SUMMARY EXPERT OPINION INDEPENDENT ANALYSIS: OVERSHADOWING

266 Longueville Road Lane Cove

3 May 2018 Revised and reissued 22 August 2018

Figure 2: Geolocated detailed model in SketchUp. View from the sun at 10.00am.

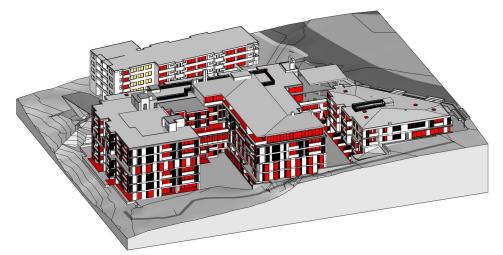
4.1.3 I examine the model by use of 'views from the sun'. The projection referred to as a 'View from the Sun' shows all sunlit surfaces at a given time and date. Figure 2 illustrates the technique.

Note that a 'view from the sun' by definition does not show any shadows. The advantage of views from the sun is that they show directly the relationship between a shadow and the object which causes it.
